**AGENDA
TECHNICAL REVIEW COMMITTEE
REGULAR MEETING
AUGUST 27, 2020
9:00 AM
CITY HALL COMMISSION CHAMBERS
204 ASH STREET
FERNANDINA BEACH, FL 32034**

Re: Bistro 2020
14 N. 2nd Street
Fernandina Beach, FL 32034
Our File #15018

SMCC PARKING LOT- PHASE 2
FINAL ENGINEERING PLANS
COVER SHEET

2 GUTTER DETAIL

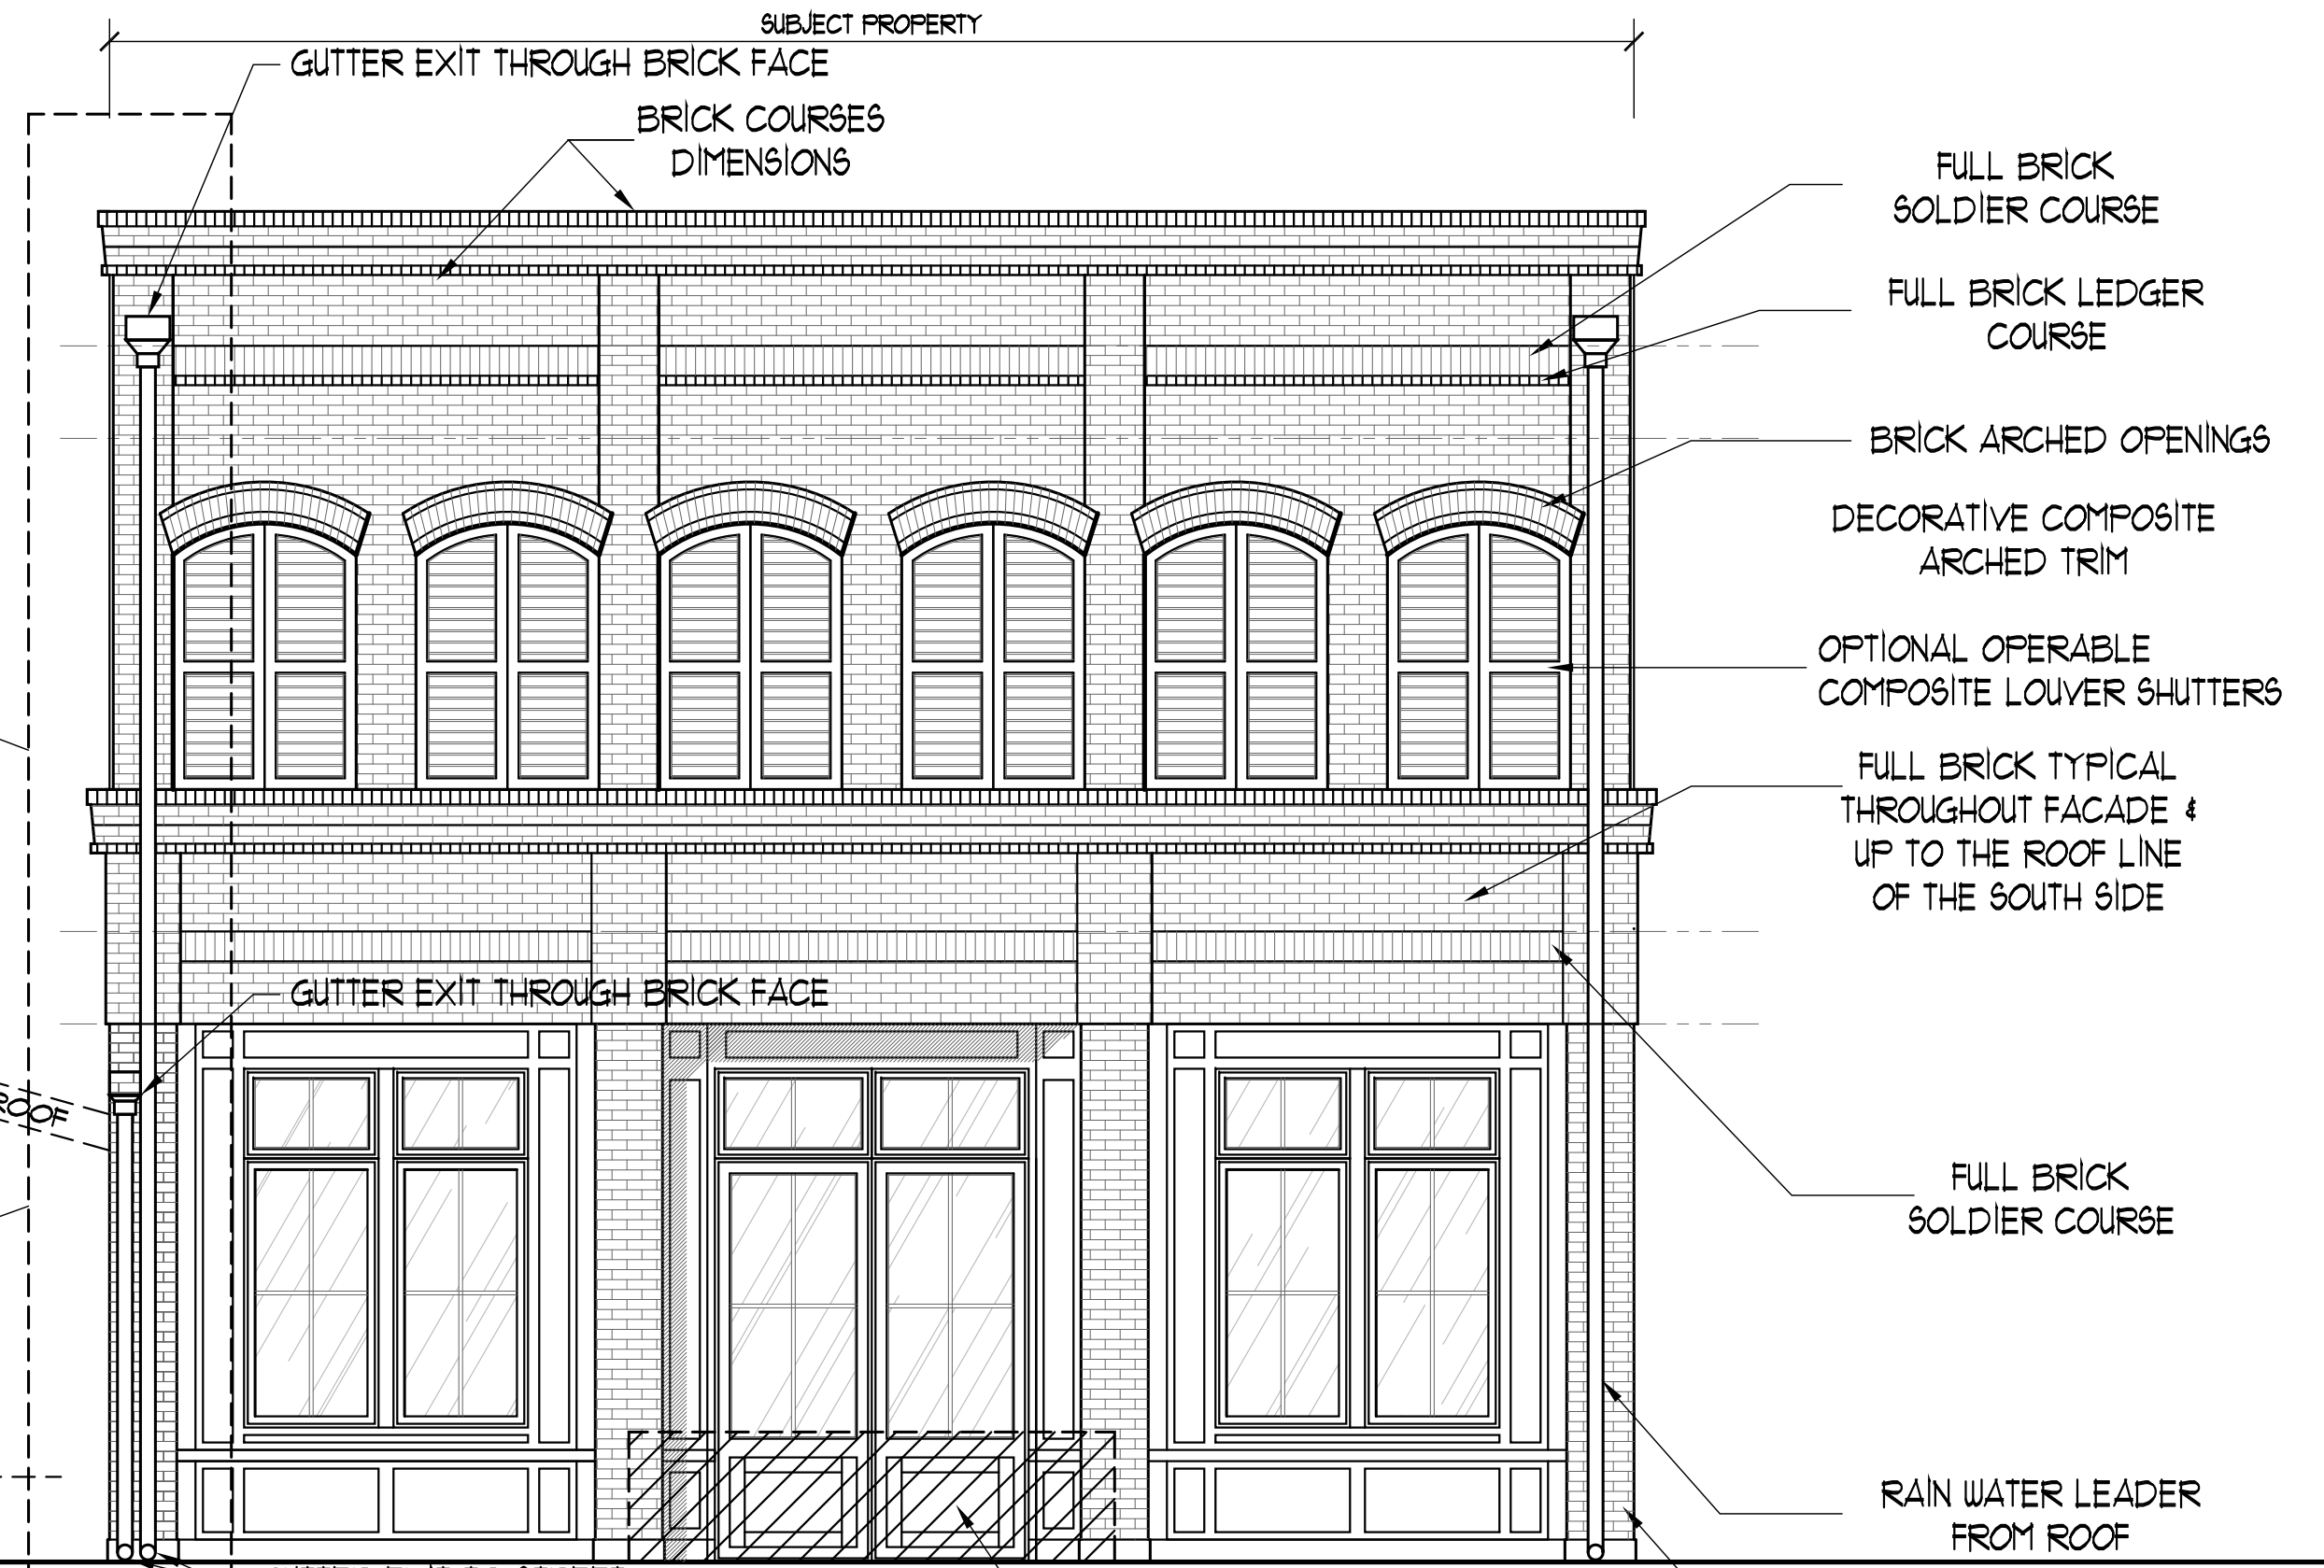
- Pg. EX- 1, please correct your code information in the general notes and specifications. The Wall Section and Gutter Details do they account for proper fire separation needs? How do you maintain this gutter system?

- The code information has been updated on sheet DTL-1. Also provided on sheet DTL-1 are the Gutter Details for gutter maintenance and Detailed Wall Section for depiction of fire rating.

SMCC PARKING LOT-PHASE 2
FINAL ENGINEERING PLANS
GEOMETRY, STRIPING &
SIGNAGE PLAN

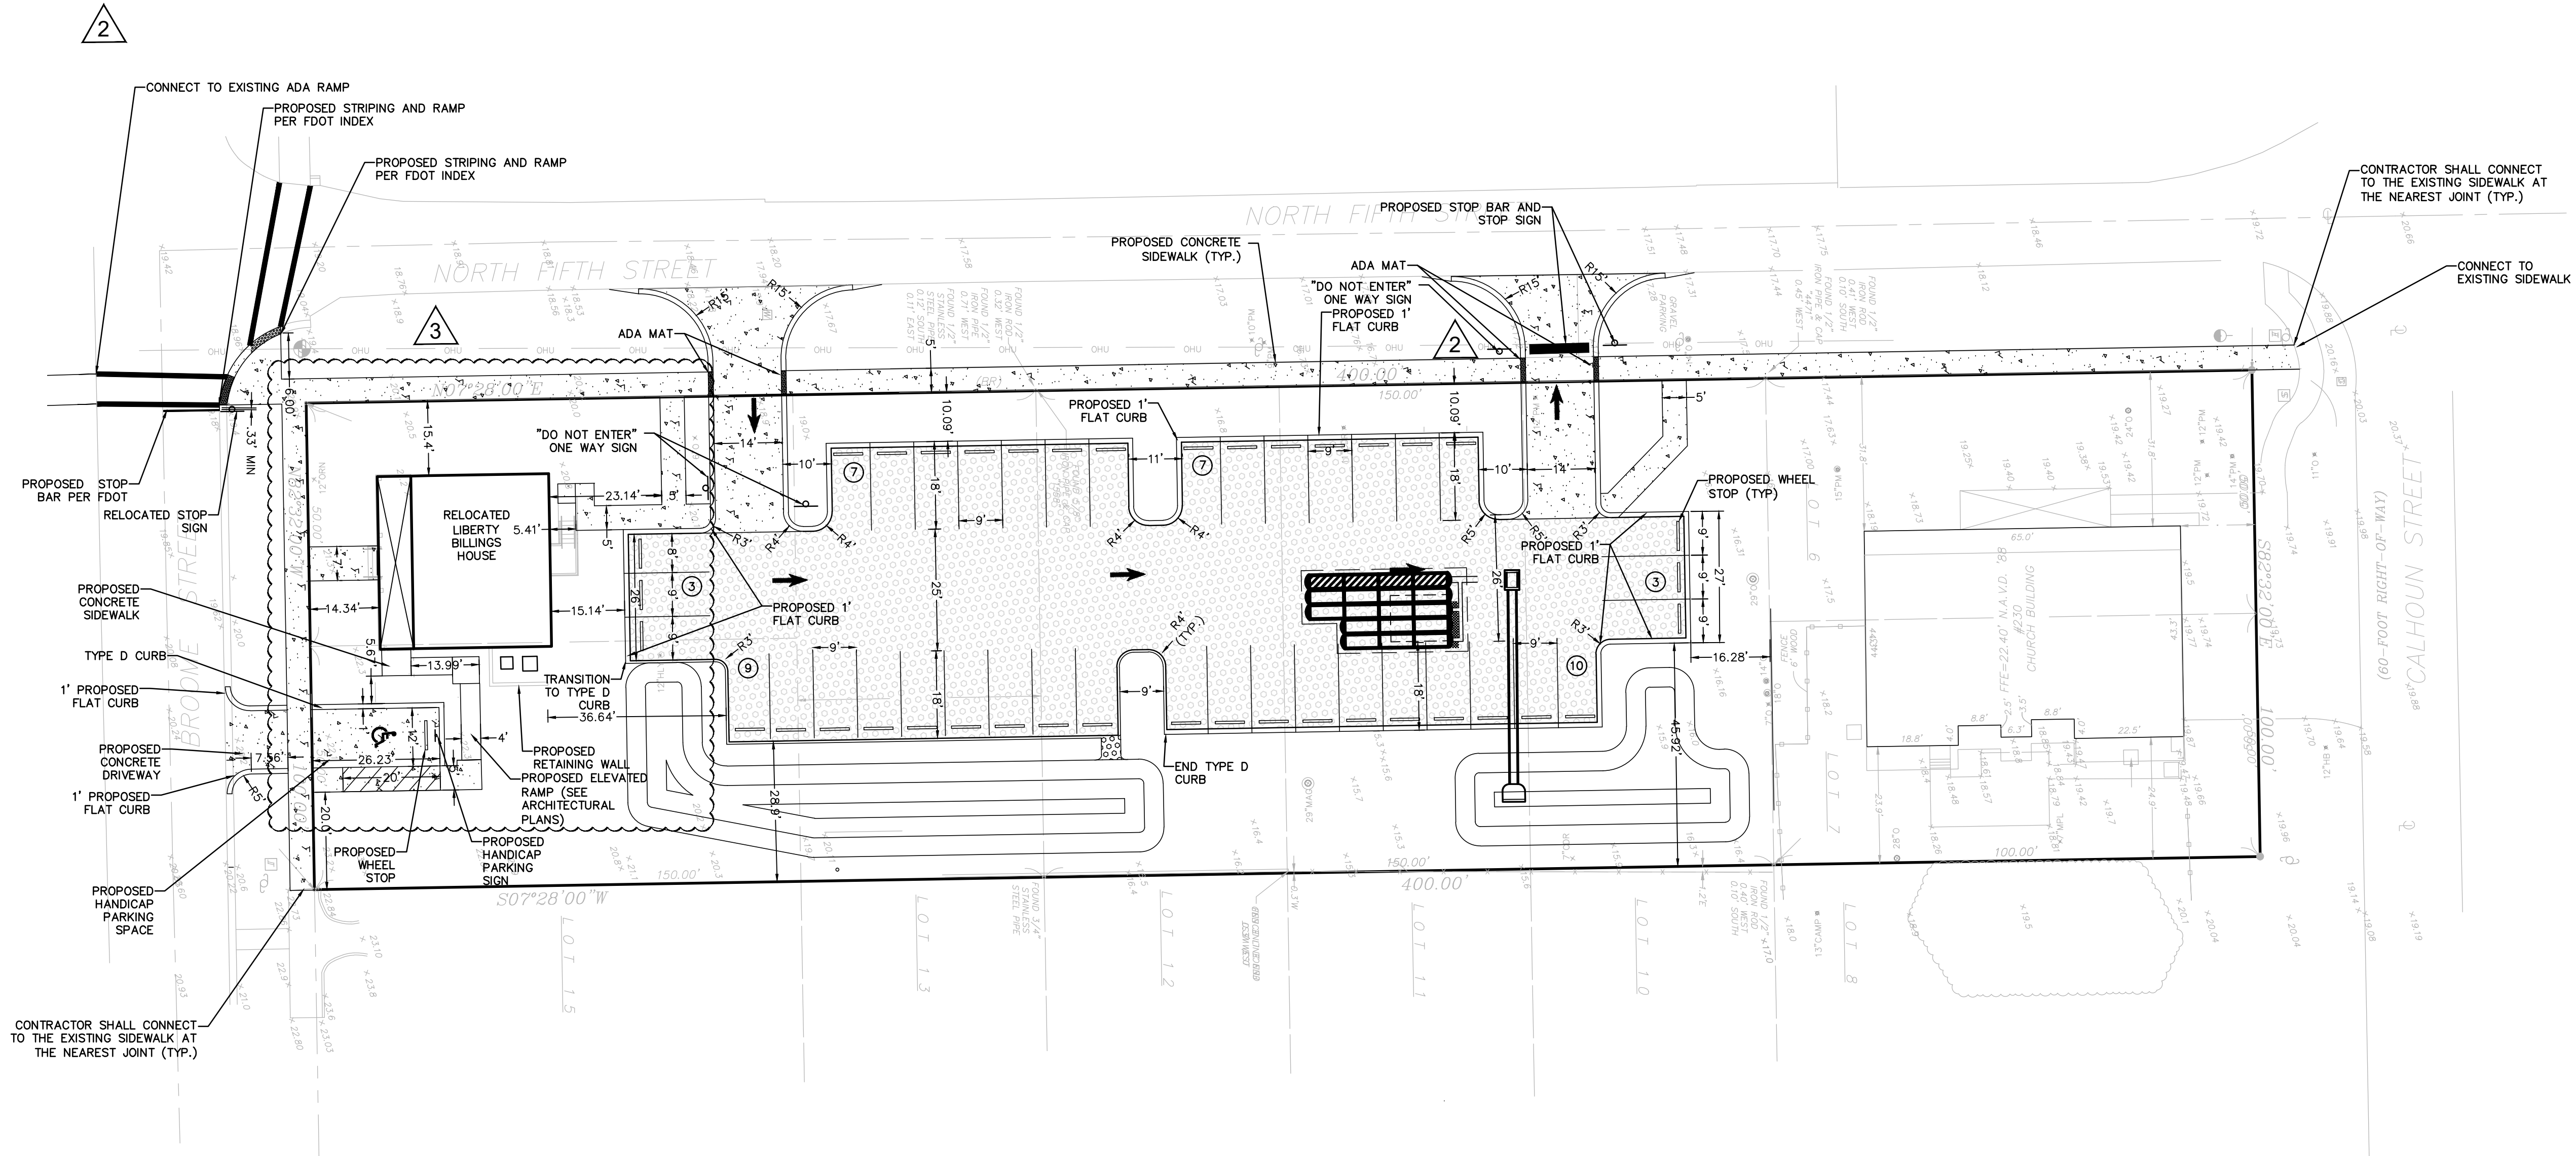
1. Sidewalk connection and crosswalk needs to be added for the eastern sidewalk across Broome Street.

RESPONSE: *Please see sheet C4 for crosswalk across Broome St.*

SMCC PARKING LOT - PHASE 2
FINAL ENGINEERING PLANS
PAVING GRADING &
DRAINAGE PLAN

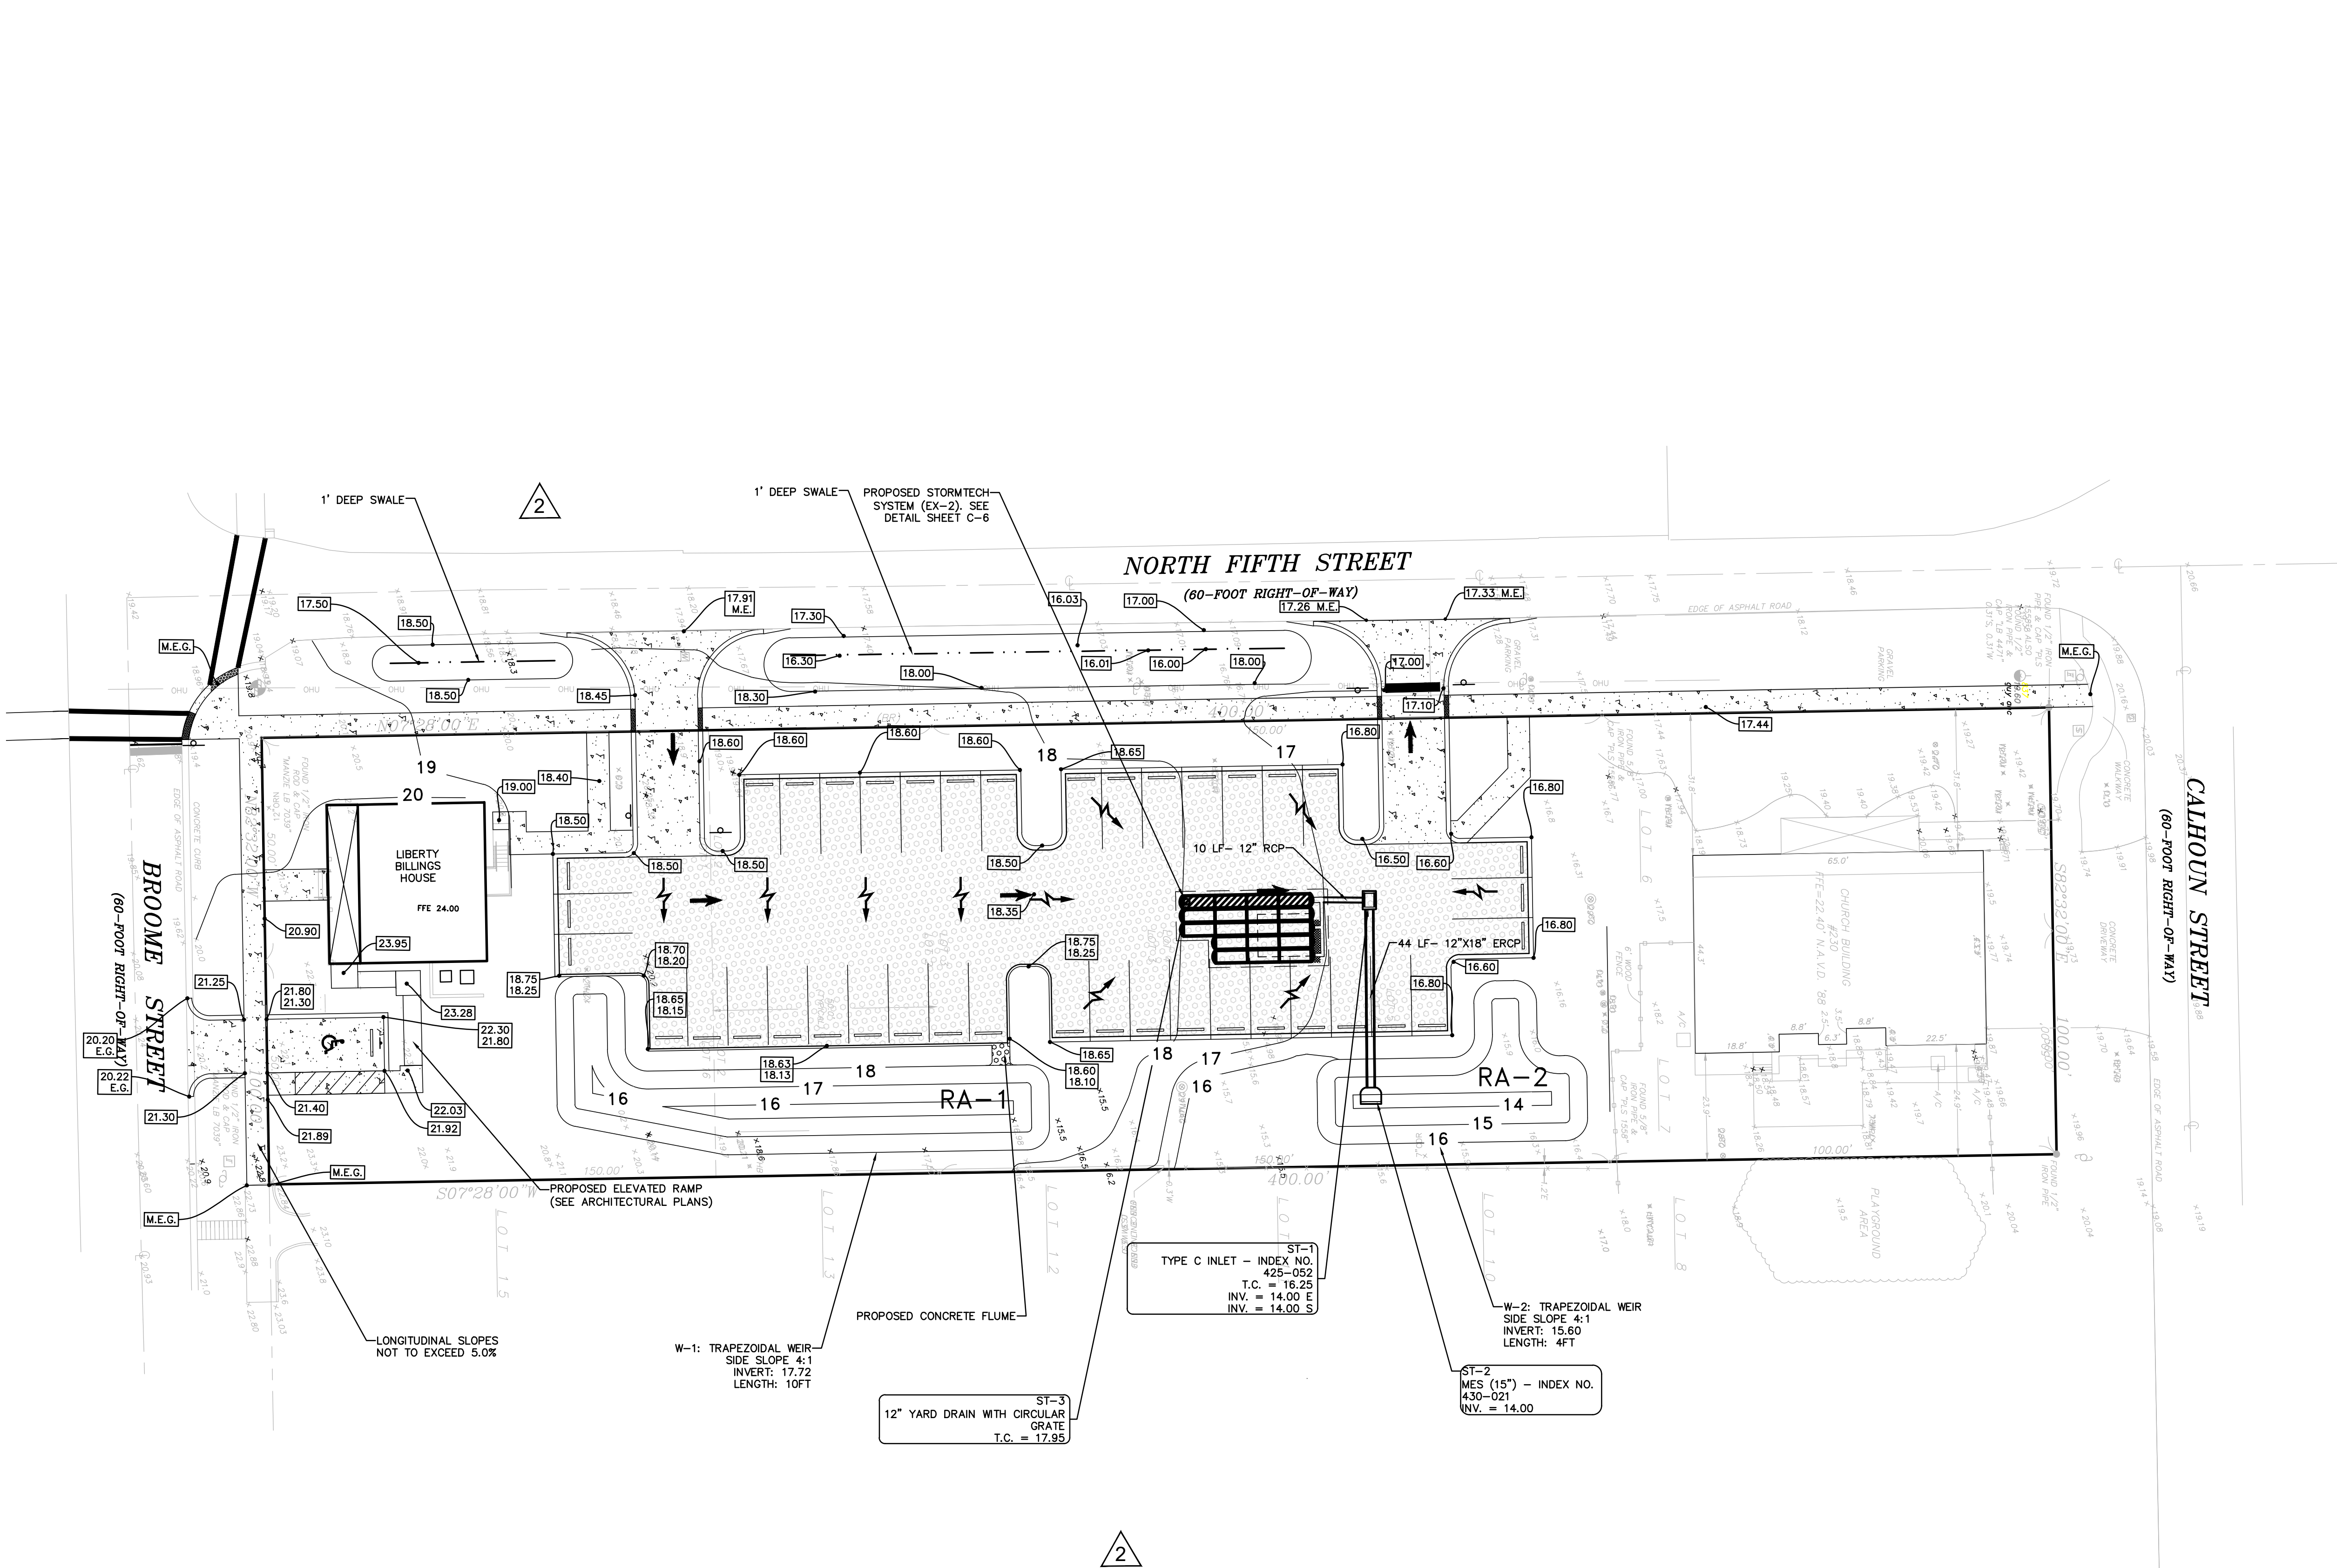
2. Please clarify if there are accommodations to access the exfiltration system for inspection and maintenance.

3. Please also note that periodic maintenance of this system to remove accumulated sediment is the responsibility of the property owner.

4. Please specify grading of shallow swales within the right of way between driveways. This will help address runoff from the adjacent roadway, and deter parking in this area. Can be done in conjunction with suggested tree plantings.

RESPONSE: *Please see sheet C9 and C10 the exfiltration trench was changed to Stormtech chambers.*

RESPONSE: *Please see note 3 on sheet C5.*

RESPONSE: *Please see sheet C5 for proposed swale and grading.*
